**CITY OF TWIN OAKS
PLANNING AND ZONING COMMISSION MEETING
BOARD CHAMBERS, TWIN OAKS CITY HALL
1381 BIG BEND ROAD
TUESDAY, JANUARY 25, 2022 6:30 P.M.**

“C” COMMERCIAL DISTRICT APPLICATION FOR PRELIMINARY DEVELOPMENT PLAN

First round comment response letter

Twin Oaks, Missouri
1100 Meramec Station Road – BFA 3497-0

A - Fabricated Letters

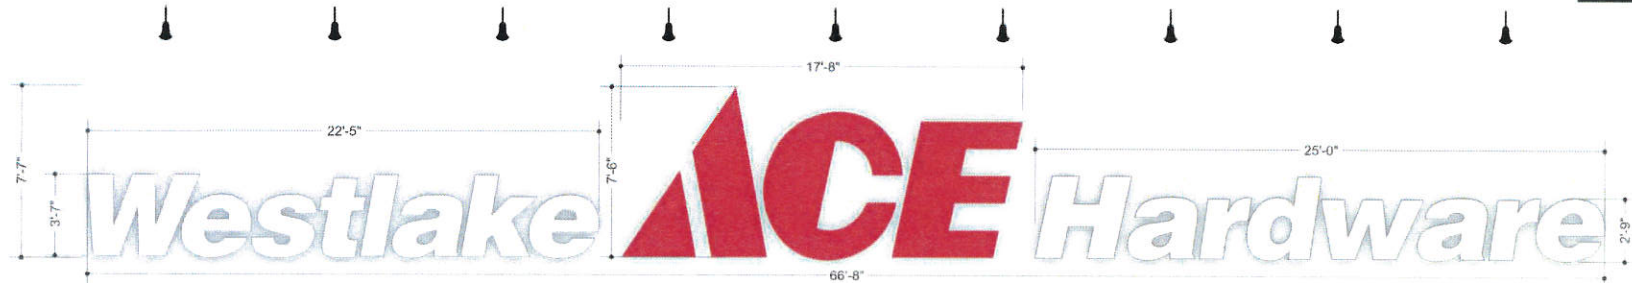
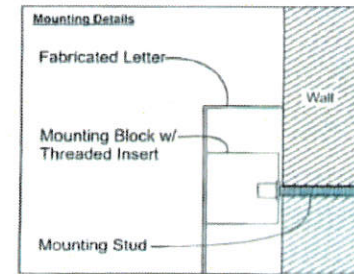
19. Wall sign: Provide dimensions of the wall to which the wall sign is attached. Ensure wall sign is not greater than 5% or no larger than 150 square feet per Section 410.050.

REFER TO ATTACHED CALCULATION (SHEET 2)
